## GOVERNMENT OF THE DISTRICT OF COLUMBIA DEPARTMENT OF CONSUMER AND REGULATORY AFFAIRS OFFICE OF THE ZONING ADMINISTRATOR

Re: Subdivision of 2910 Garfield Street, NW, Washington, DC (Square 2113, Lot 828) – Approval of Subdivision and Granting of Zoning Administrator Flexibility Provided Under Section 407.1 of the Zoning Regulations

2910 GARFIELD STREET, NW LOT 828, SQUARE 2113 SUBDIVISION CONCEPT SKETCH "A" SCALE: N.T.S.

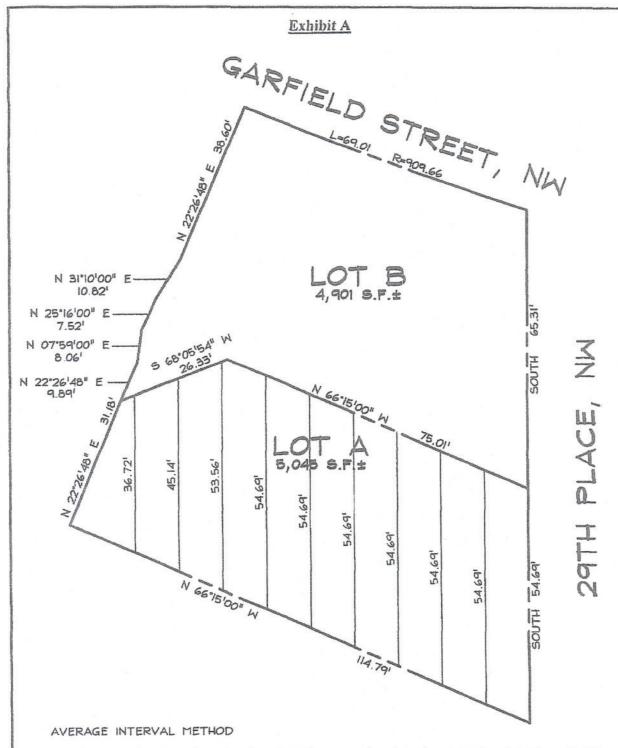
As you know, the R-1-B Zone District requires a lot area of 5,000 square feet and a minimum lot width of 50 feet. Your proposal shown on Exhibit A is comprised of Lot A which contains 5,045 square feet and a lot width of 51.9 feet and Lot B which contains 4,901 square feet and a lot width of no less than 65.31 feet.

The Zoning Administrator is authorized to permit a deviation not to exceed two percent (2%) of the area requirement of Section 401.3 provided that (a) a building shall be allowed to deviate from the requirements of not more than two (2) of Sections 401, 403, 404, 405 and 406 and (b) the deviation shall be deemed by the Zoning Administrator not to impair the purpose of the otherwise applicable regulations. The configuration shown on Exhibit A satisfies both of these elements of Section 407.1 since you are not requesting any other area of deviation from the Zoning Regulations and since your request will not impair the purpose of the otherwise applicable Zoning Regulations. Therefore, the configuration shown on Exhibit A is approved as shown.

Further, the method of calculation of the width of Lot A on Exhibit A is approved. As you know, the required lot width may be met, in the case of an irregularly shaped lot such as Lot A, by an average width of lot calculation, as further described in this letter Section 199.1 of the Zoning Regulations defines "lot width" as follows:

As a matter of standard interpretative practice, the Zoning Administrator has determined average width of lot by a method which (a) draws lines perpendicular to and intersecting the side property lines at ten (10) foot intervals, starting from and parallel to the front property lot line, (b) sums up the linear distance of drawn lines, and (c) divides the total linear distance by the number of lines drawn to arrive at the average width of lot. Further, the definition of lot width under Section 199 1 of the Zoning Regulations clearly defines lot with as "the distance between the side lot lines" (emphasis added). Therefore, additional ten (10) foot distance measurements are not required for portions of the lot that do not include side lot lines, such as the rear portion of Lot A.

36 72' + 45 14' + 53 56' + 54 69' + 54 6

518 25 / 10 = 51 825

519 > 50 - THEREFORE, GOOD
